## #2011-06 Banner Apartments Senior Housing Project Review for Planning and Zoning Commission

**Location:** Station Drive (345-375 Station Drive)

Project Title: Senior Residences of Crystal Lake

**A SOUTH ELEVATION (FRONT)**

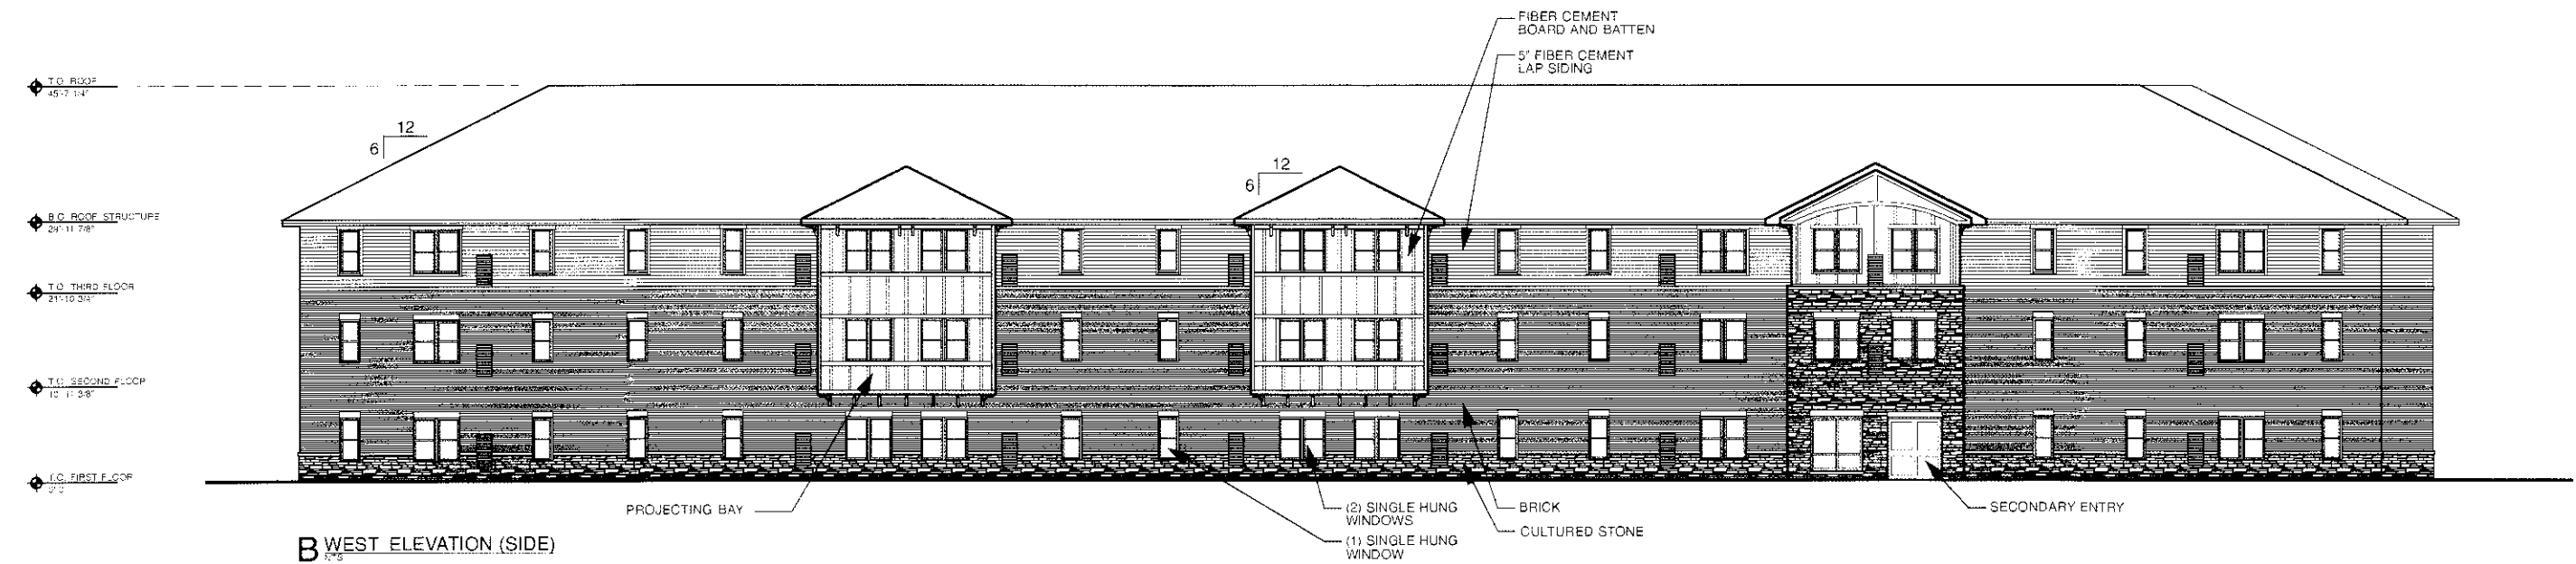
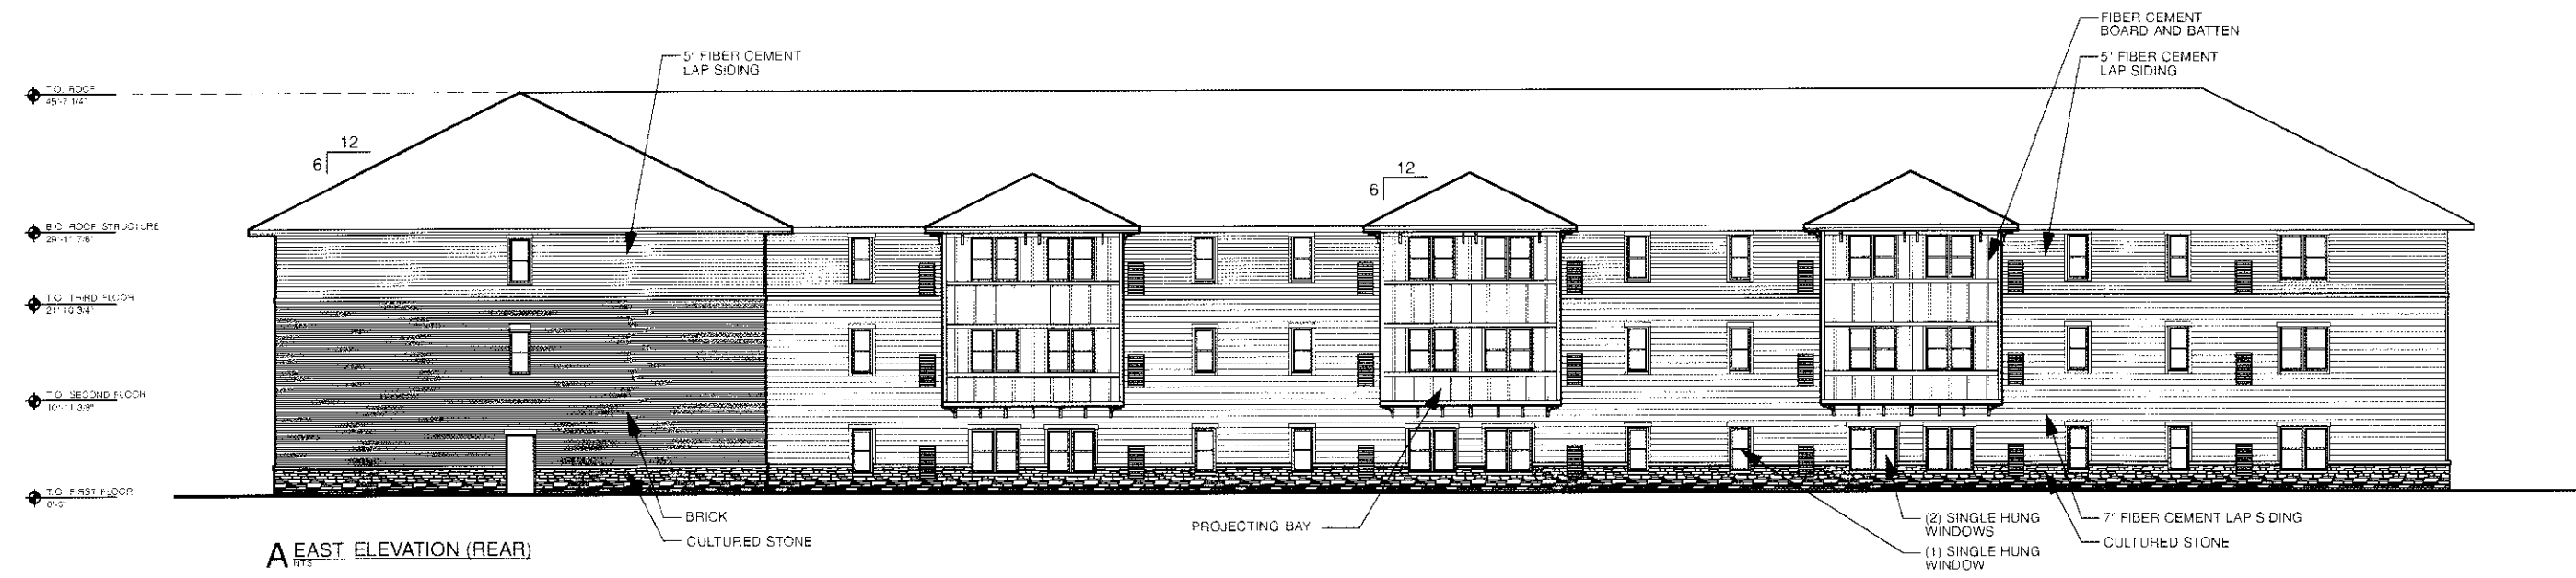
- B. To provide better definition in the elevations all windows shall have a stone top cap and bottom sill.
4. Plat of Resubdivision
- A. Revise the plat so that Outlot 1 is not shown within Lot 1.

# PRELIMINARY PLAT OF RESUBDIVISION OF CONGRESS STATION 2

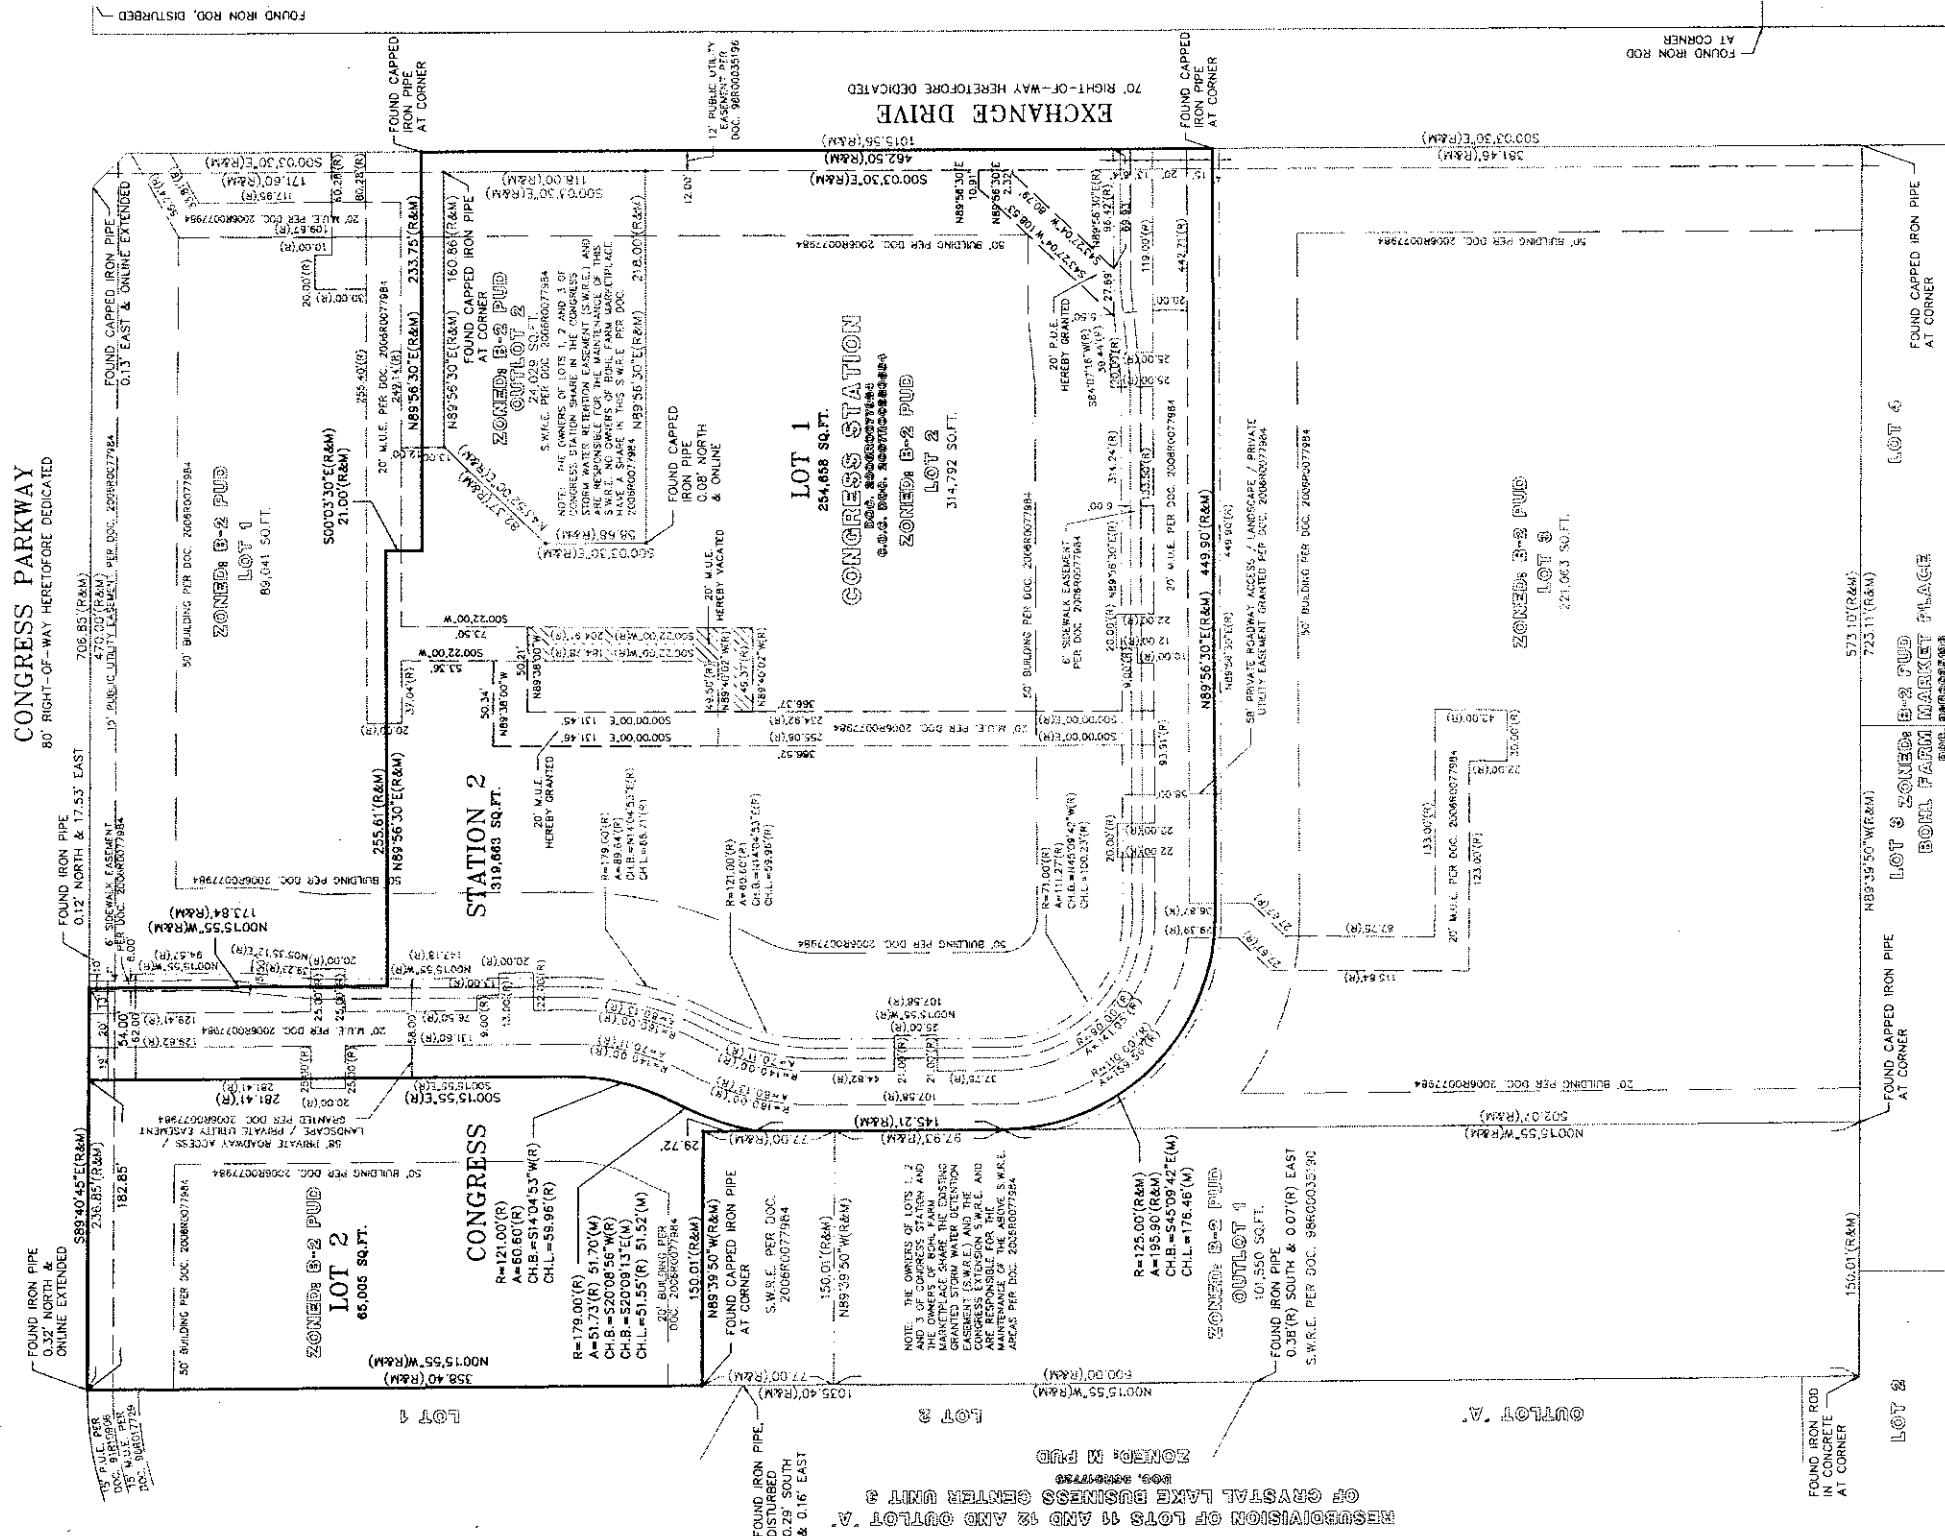
- B. Create a separate outlot labeled Outlot 3 for the Roadway Access/ Landscape/ Private Utility Easement.
  - C. Provide a final copy of the revised CC&R's

GEOMETRIC PLAN

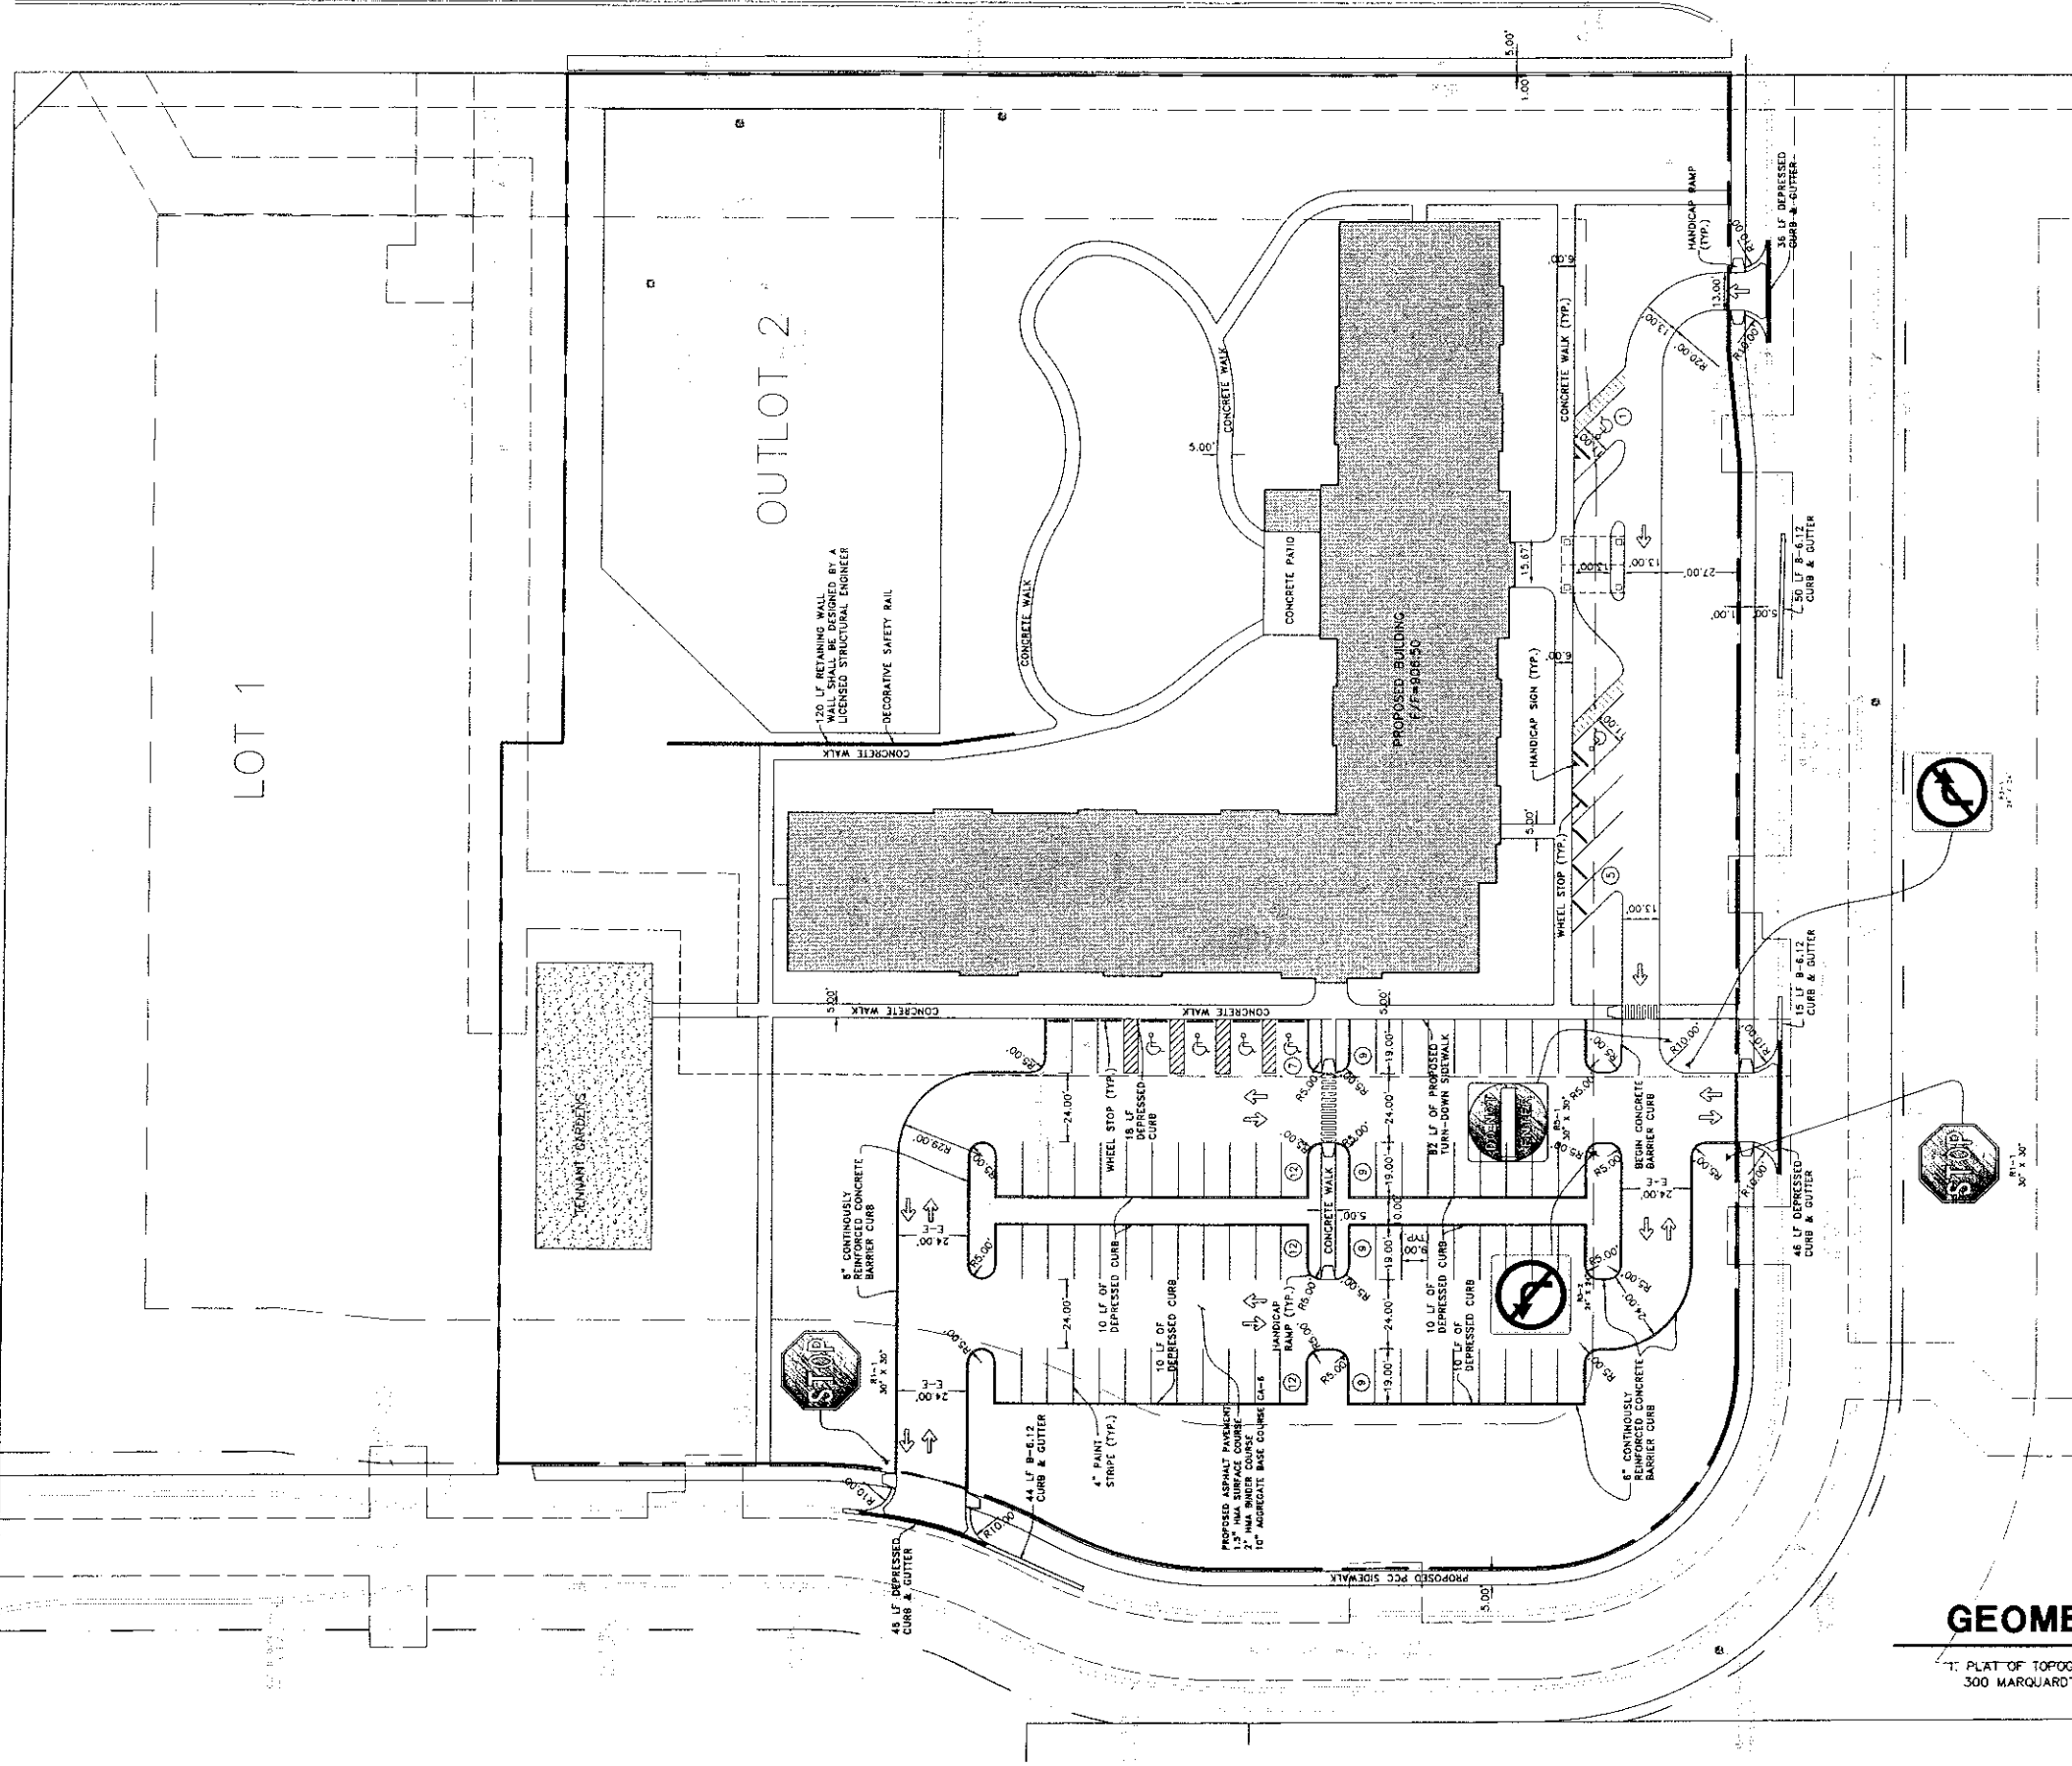
2. Site Plan
  - A. Aerial apparatus access roads shall be 26 feet in width within a minimum of 15 feet and a maximum of 30 feet from the building. The south access and the west access will need to increase in width.

- B. The fire apparatus access should not be greater than 250 feet to any portion of the building from an approved fire apparatus access. The fire access lane may need to be extended to meet this requirement.

- C. Except for the designated parking areas, the access roads shall be posted "No-parking Fire Lane and Station Drive will need "No-Parking Fire Lane" on the side with the fire hydrants.

- D. Provide an auto-turn exhibit indicating that a fire truck can access the entrance closest to Exchange Drive. Due to the proximity of the entrance to Exchange Drive, the entrance must remain one-way inbound.

- E. The one-way entrance off Station Drive shall not be moved closer to Exchange Drive.
  - F. Illustrate the location for the trash enclosure, ensure it is readily accessible to a waste hauling truck.
